UNITED STATES NUCLEAR REGULATORY COMMISSION

In the Matter of	:	
	:	Docket Nos. 50-277
PHILADELPHIA ELECTRIC COMPANY	:	50-278

APPLICATION FOR AMENDMENT
OF
FACILITY OPERATING LICENSES
DPR-44 & DPR-56

APPLICATION FOR AMENDMENT
OF
FACILITY OPERATING LICENSES
DPR-44 & DPR-56

Figures 3.10.E.1 through 9

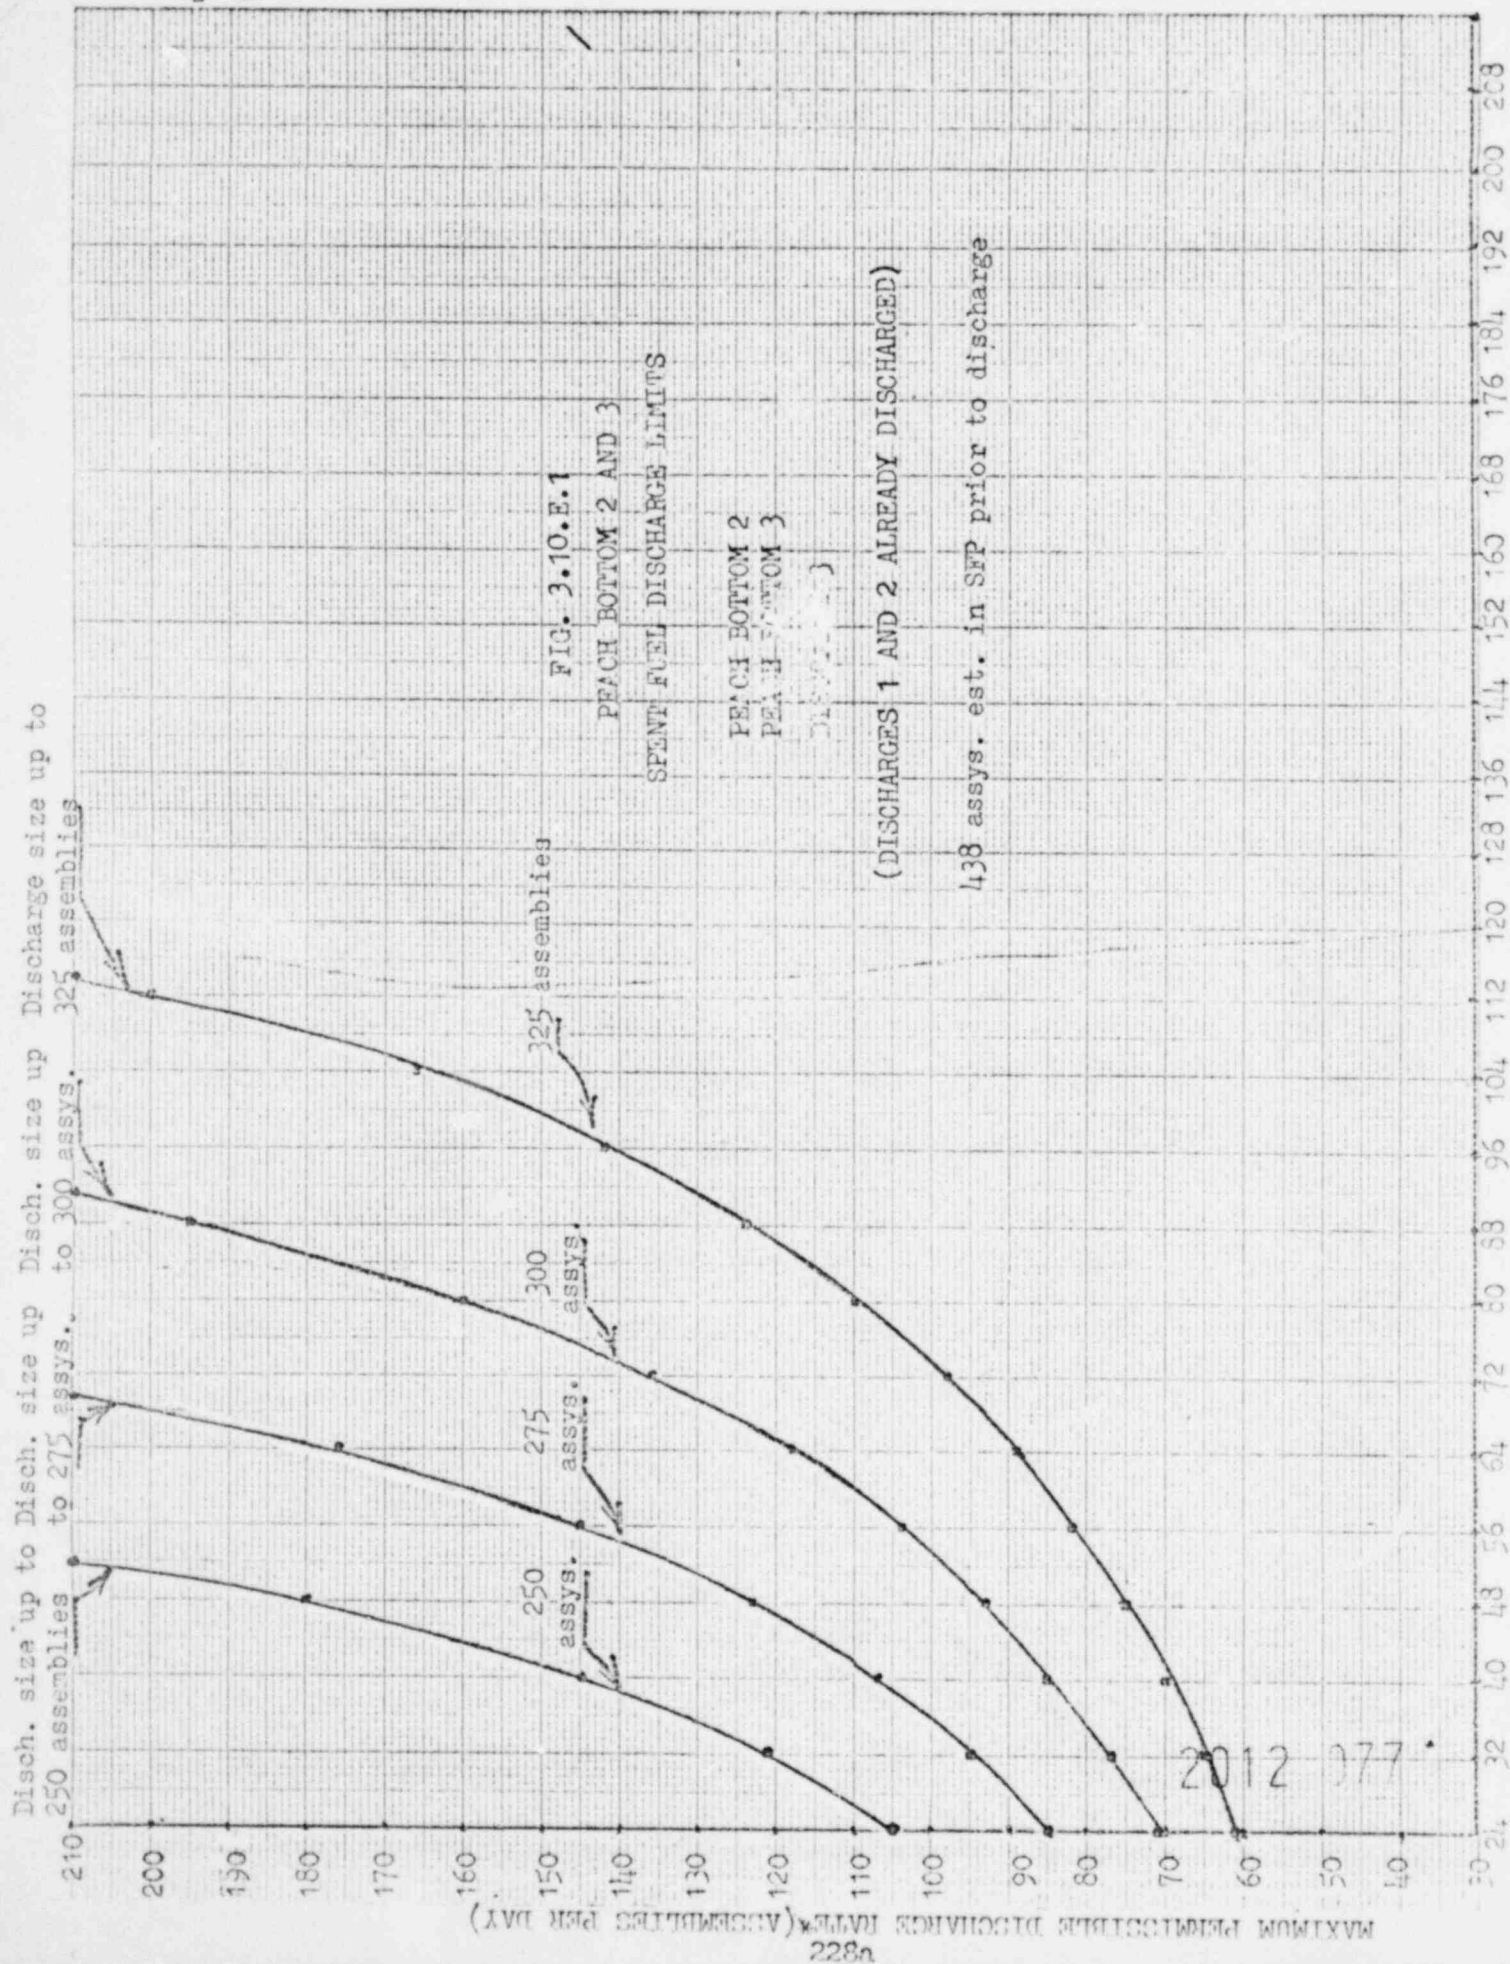
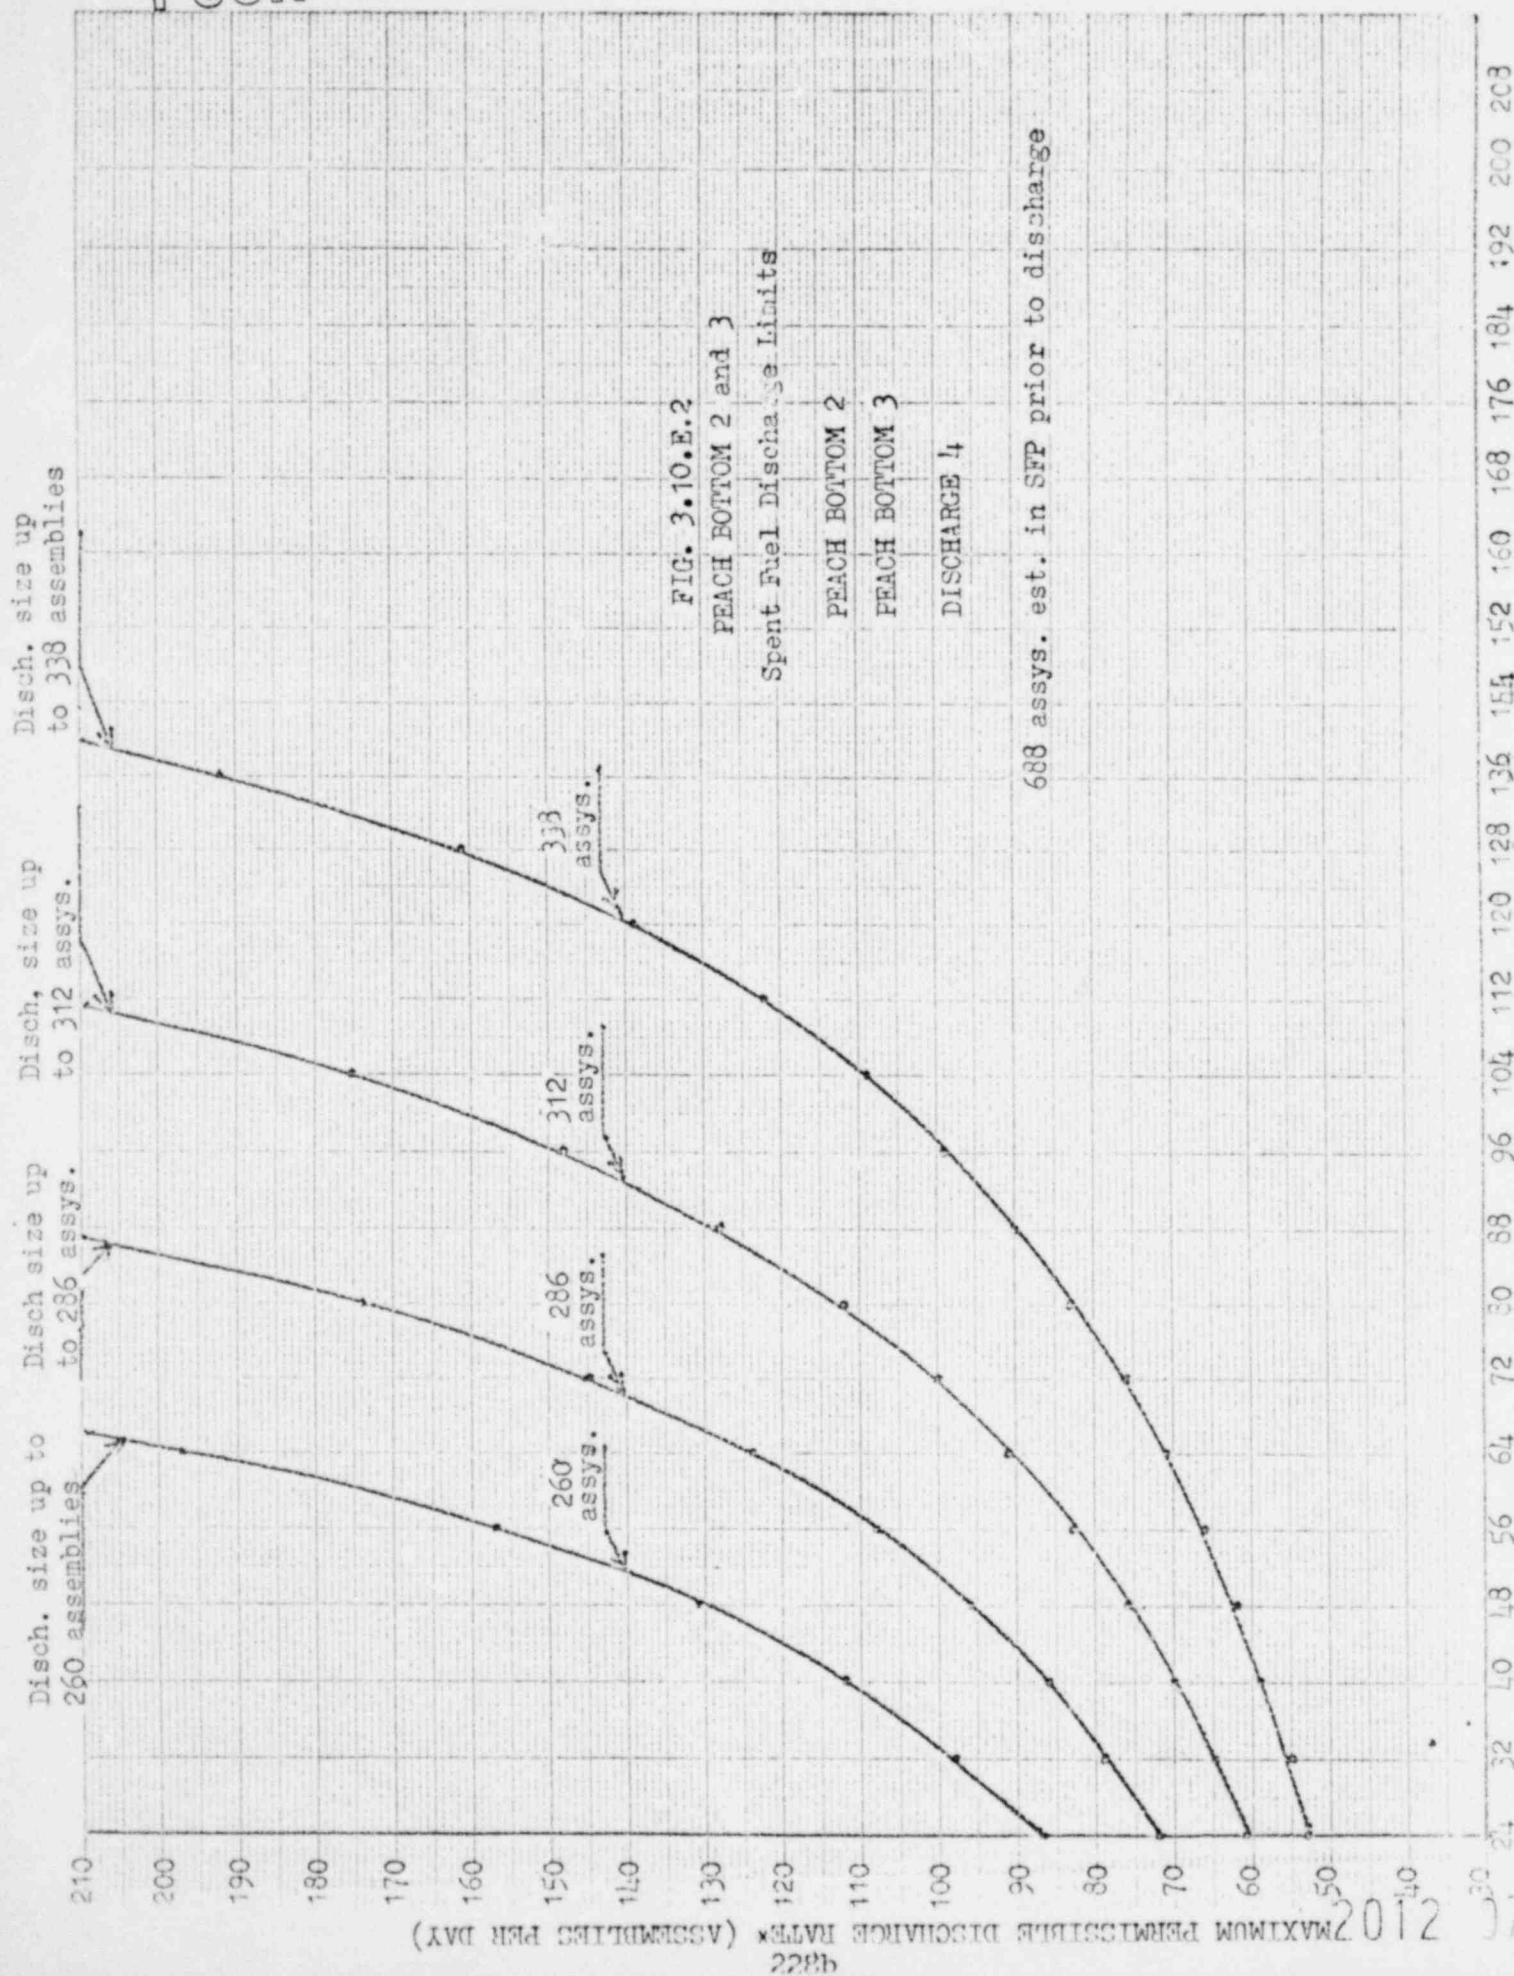
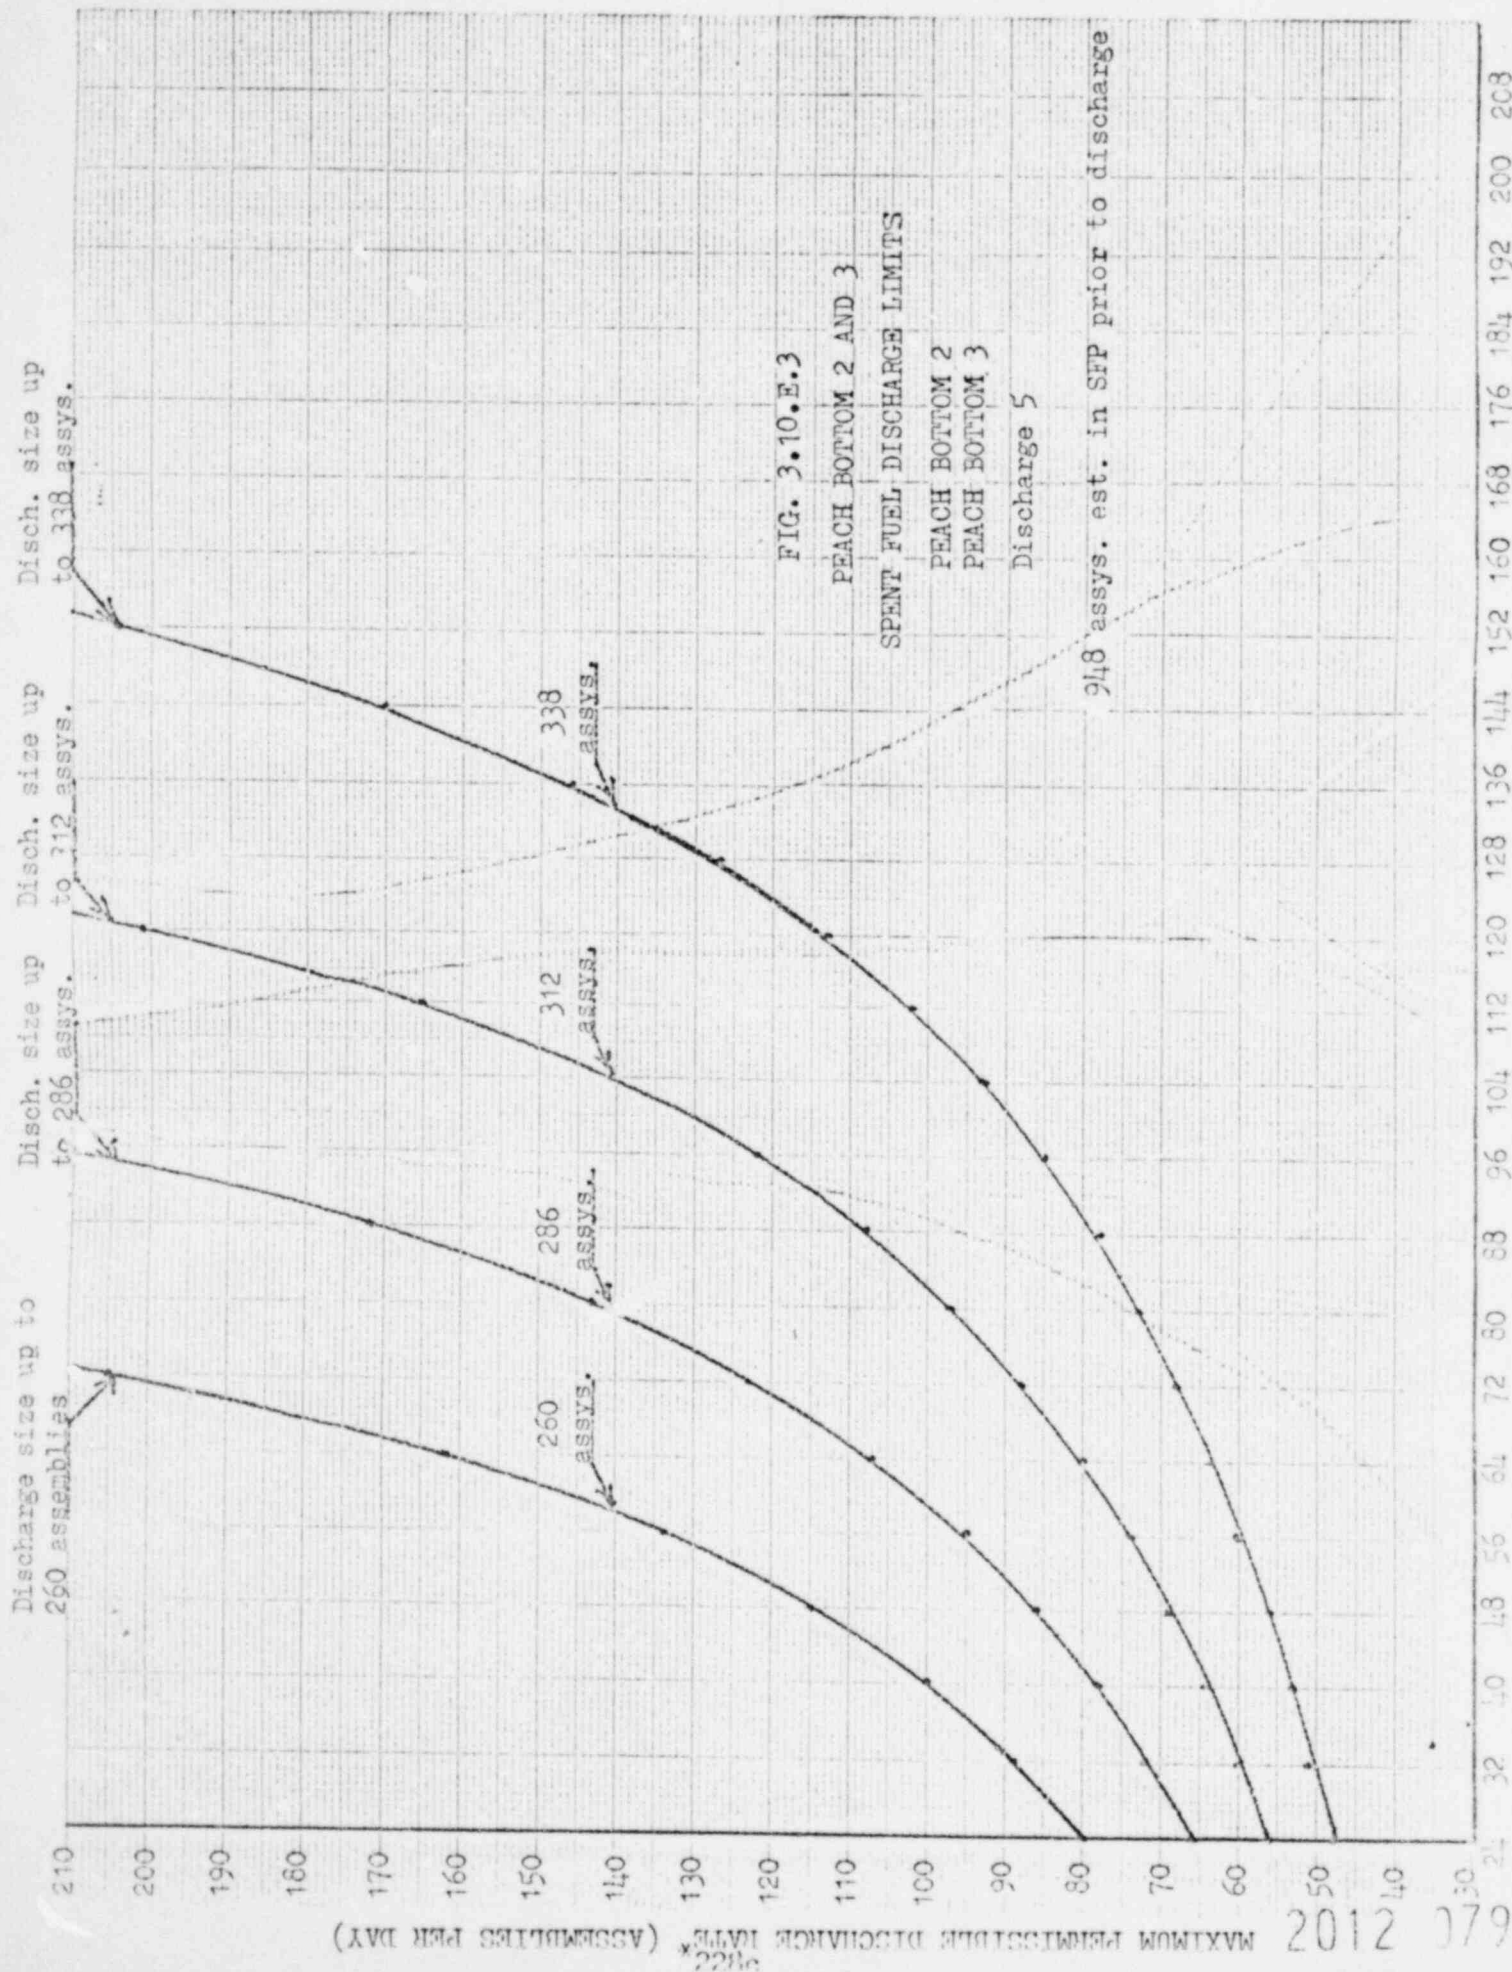
The Licensee proposes revisions to Technical Specification, section 3.10.E, that change the limiting conditions for the discharge of spent fuel from the reactor vessel to the Spent Fuel Pool. The revised limits would permit a spent fuel discharge rate based on the elapsed time following the reactor shutdown, the quantity of fuel to be discharged, river water temperature, and the discharge cycle (number). A description of the safety analysis is included in section 3.10.E BASES on page 230a. The safety analysis, using data and assumptions previously submitted on January 19, 1978, in support of the installation of high density racks in the Peach Bottom spent fuel pools, was performed to develop the maximum permissible discharge rates shown in the proposed figures 3.10.E.1 through 9.

In order to maintain SFP temperature less than or equal to 150°F, the rate of discharge of spent fuel assemblies from the reactor to the spent fuel pool shall not exceed the maximum permissible discharge rate obtained from Figures 3.10.E.1 through 9, whenever the spent fuel pool cooling system is in use. No limitations are required whenever the Residual Heat Removal System is arranged for spent fuel pool cooling.

- 1) Using the discharge (cycle) number, select the corresponding figure from Figures 3.10.E.1 through 9.
 - 2) Select the one curve (of the four in the figure selected in item 1 above) which corresponds to the discharge size next highest to (or equal to) the total number of assemblies to be moved to the SFP during the outage.

- 3) Using the time from reactor shutdown to first fuel assembly discharged (ordinate) which is achieved during the outage, read the coordinate maximum permissible discharge rate* from the curve selected in item 2) above. This maximum permissible discharge rate shall be used as a limit during the outage, in order to maintain SFP temperature less than or equal to 150°F.

- 4) If it is desired to correct the maximum permissible discharge rate for cooling (river) water temperatures, determine the river water temperature at time of first discharge and every 24 hours thereafter. Using the appropriate correction factor, multiply the maximum permissible discharge rate obtained in item (3) above by the correction factor for that 24 hour period. The corrected maximum permissible discharge rate shall be used as a limit during the corresponding 24 hour segment of the outage. Correction factors are as follows:

- a) 71°F - 80°F cooling water: 1.5
 - b) 61°F - 70°F: 2.5
 - c) 60°F or lower: 4.0
 - 5) The maximum permissible rate operates cumulatively; that is, if the permissible rate for a particular discharge is 100 assemblies per day and only 50 assemblies are discharged the first day, then 150 may be discharged the second day.
